REQUEST Current Zoning: R-3 (single family residential)
Proposed Zoning: R-12MF(CD) (multi-family residential, conditional)

LOCATION Approximately 7.05 acres located on the east side of South Tryon Street, north of Shopton Road West.
(Council District 3 - Mayfield)

SUMMARY OF PETITION The petition proposes to allow up to 72 multi-family residential units on vacant land located to the south of the Rivergate Mixed Use Activity Center.

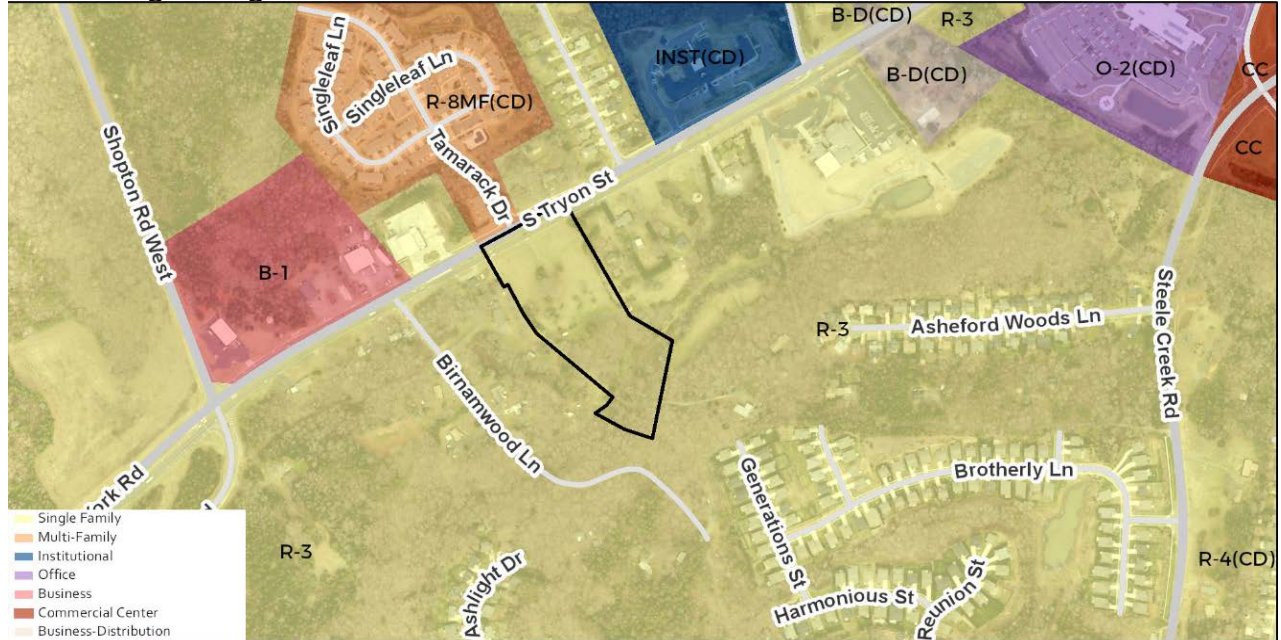
1. Reduce unit count to comply with Steele Creek Area Plan density recommendation of eight dwellings per acre. **Not addressed.**
2. Provide a buffer/fence for the single family residential property located to the southwest of the subject site. **Not addressed.**

3. ~~The petitioner should revise the site plan to show Public Street A 71' right-of-way extending to the southern property line and construction a future connection to existing Generation Street.~~ **Addressed.**
4. ~~The petitioner should revise the site plan to show Public Street B with parallel parking. If angled parking is desired, must be reverse angle with 14' wide travel lane adjacent to the angle parking and 10' wide travel lane adjacent to the parallel parking (total 24' travel width). Reverse parking stall depth is 18' (measured perpendicular to the curb), stall width is 10.5' (measured parallel to travel lane).~~ **Addressed.**

5. ~~Site is in a wedge and will be required to provide 15% tree save area based on gross acreage. 15% of 7.05 acres = 1.05 acres tree save. Show tree save and calculations area on site plan. Tree save must contain existing healthy tree canopy. Tree save must be 30 feet width minimum.~~ **Addressed.**
